Morlais Project

Terrestrial Ecology Assessment Update

Document Reference: PB5034-RHD-ZZ-XX-NT-Z-1000

Morlais Document No.
MOR/RHDHV/DOC/0110

Drawing no. 122938-BVL-Z0-00-DR-C-00600 Revision: P02

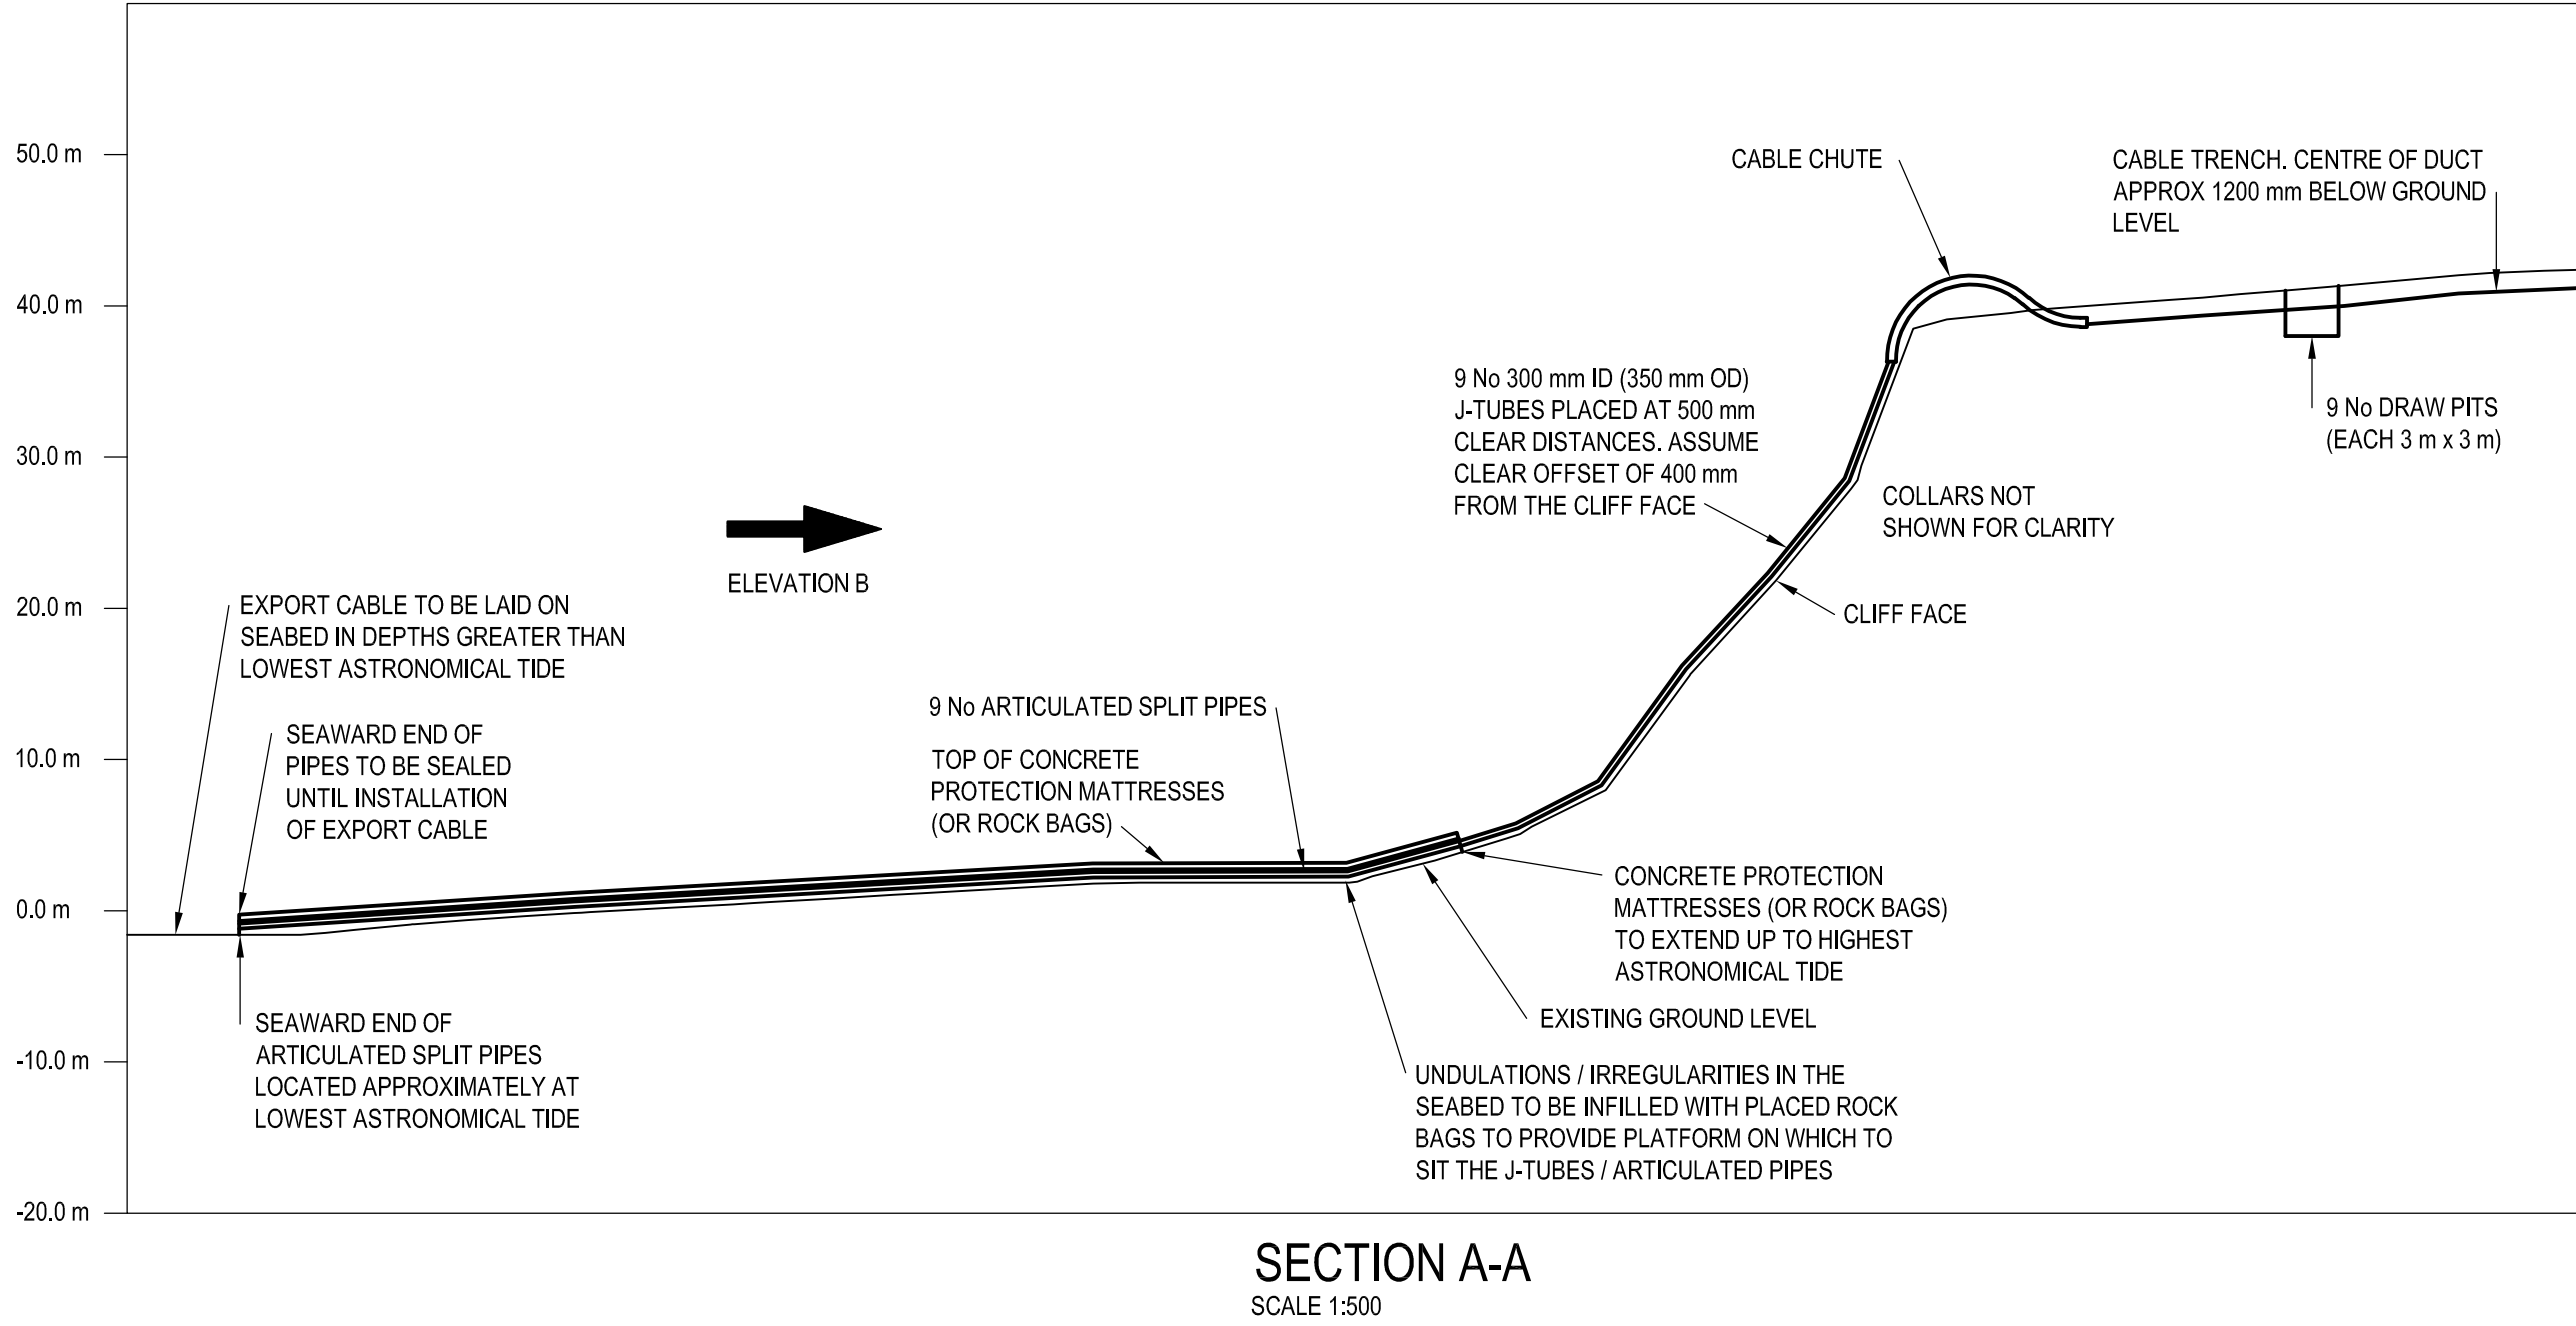
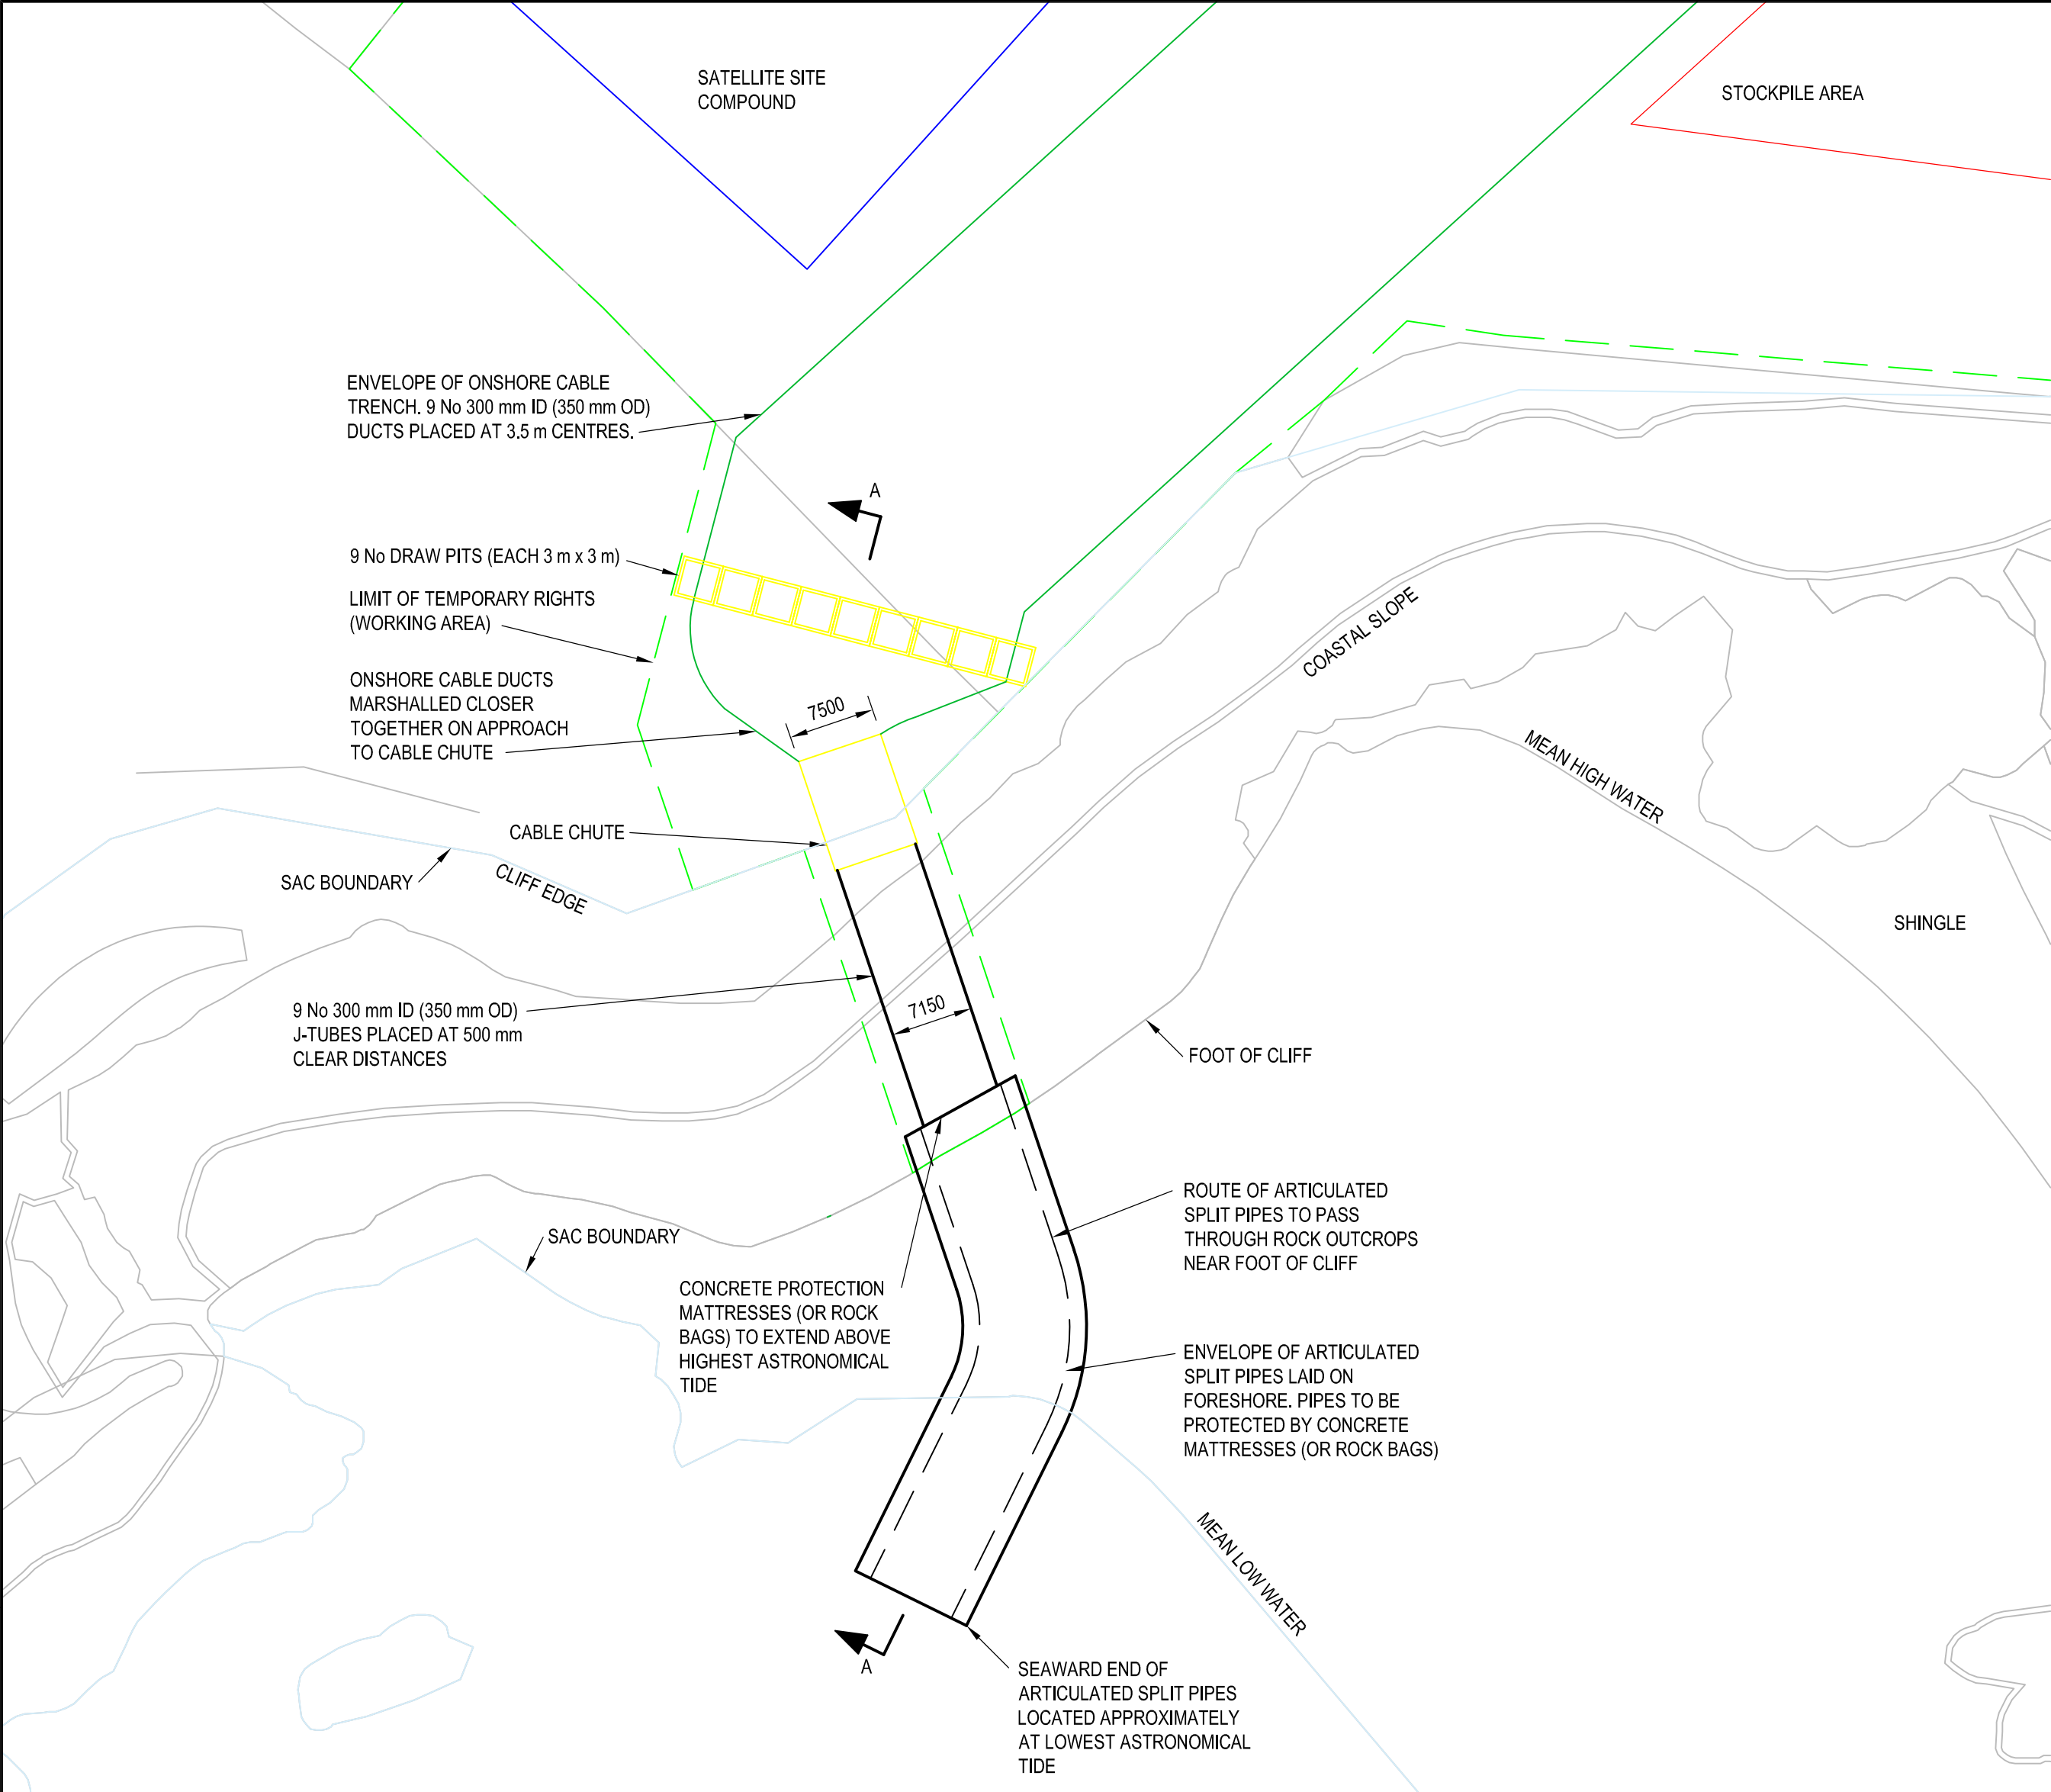
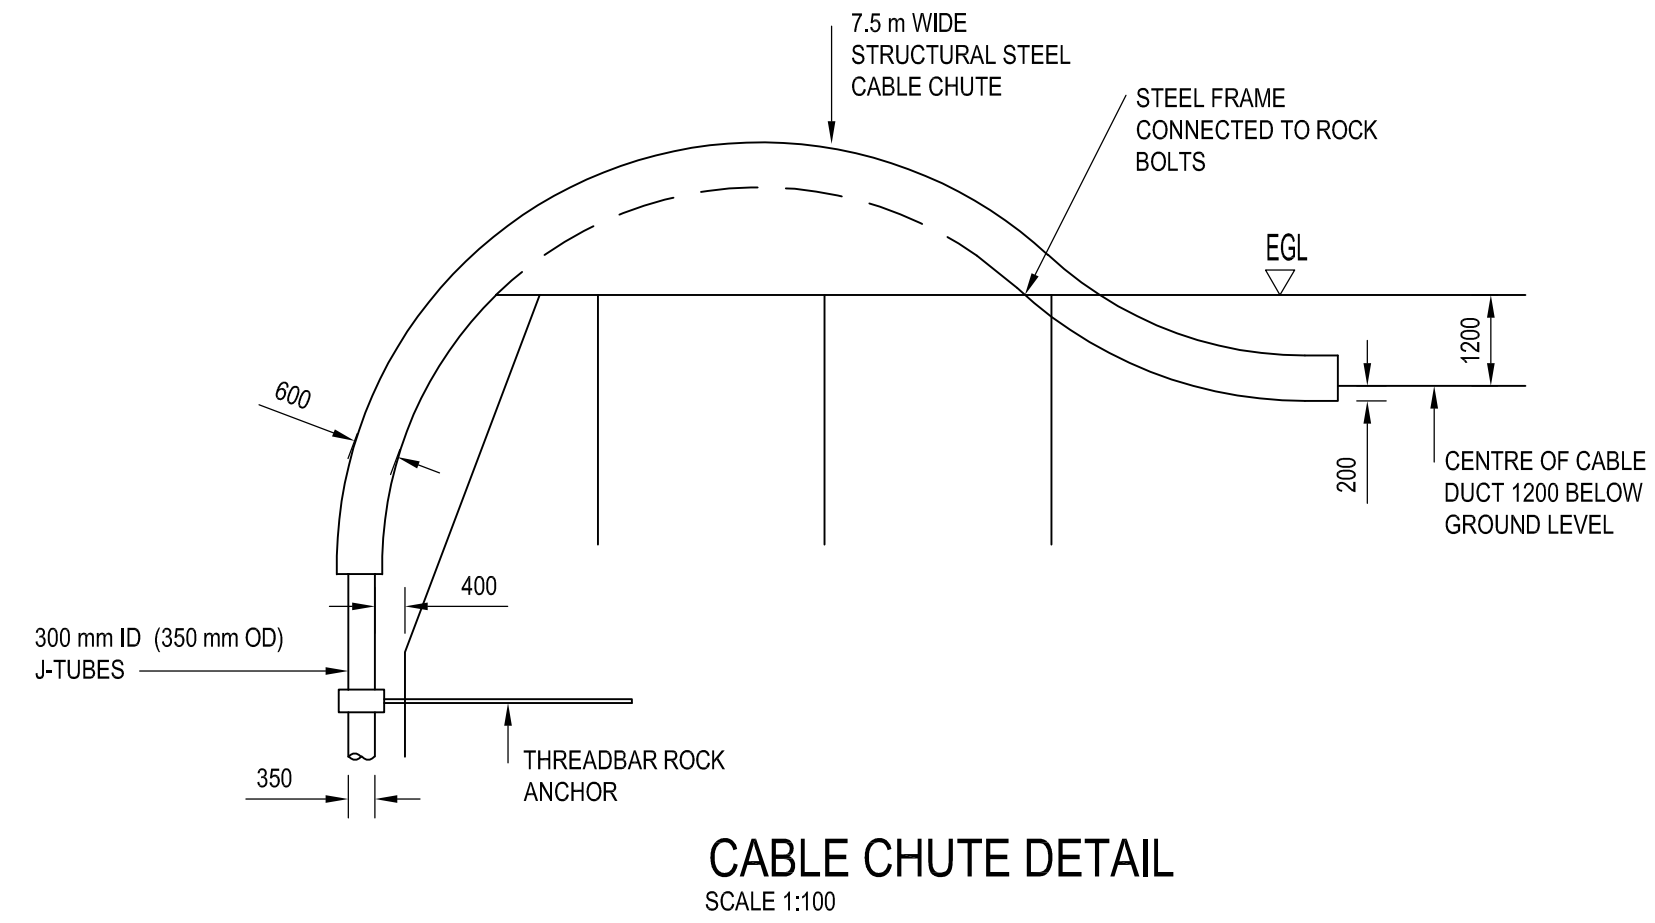
2	Drawing 2: Concrete apron at toe of cliff – up to Highest Astronomical Tide. There is a need to assess whether any qualifying SSSI features are present in this area: rockpools, caves and overhangs under boulders	These features do not appear on the citation for the SSSI https://naturalresources.wales/media/656113/SSSI_0963_Citation_EN001c75d.pdf
3	Drawing 2 shows the wrong SSSI boundary at the north-west end of the area where cables come ashore. It should follow mean low water but at c SH215815 the low water mark disappears and only the high water boundary is left.	Drawing 2 has been amended to better define the SAC boundary
4	The areas shown for stockpiles still seem quite small relative to the volumes of material to be stored, even allowing for opening trenches in short sections. Turf storage usually requires a lot of space.	For the construction phase of the project, a detailed Materials Management Plan will be developed by the contractor and submitted for acceptance by the client. All construction works will be programmed and undertaken to meet any planning and environmental constraints that are imposed on the works. It is however anticipated that the works will be phased to minimise environmental impact and disruption to local receptors. Construction of the works will be phased to suit available land take (e.g. stockpile and laydown areas) which

19	We would seek clarity over the reasons why Option A has been selected over Options B and C, as from Figure 1 it appears that a larger area of vegetated vertical sea cliff would be affected compared to Option C and to a lesser extent Option B. We would value seeing the process and reasons as to why Options B and C have been ruled out.	The project engineers (Black & Veatch) determined that Option A has the greatest stability for allowing the engineering of pinning the cables to cliff. Options B and C were discounted prior to application due to significant areas of fractured rockface (B) and access restrictions for construction machinery / proximity to only public right of way to beach (C). Both Options B and C would also require impacting a larger section of cliff and vegetation than Option A. A is the most stable area for pinning the cables to.
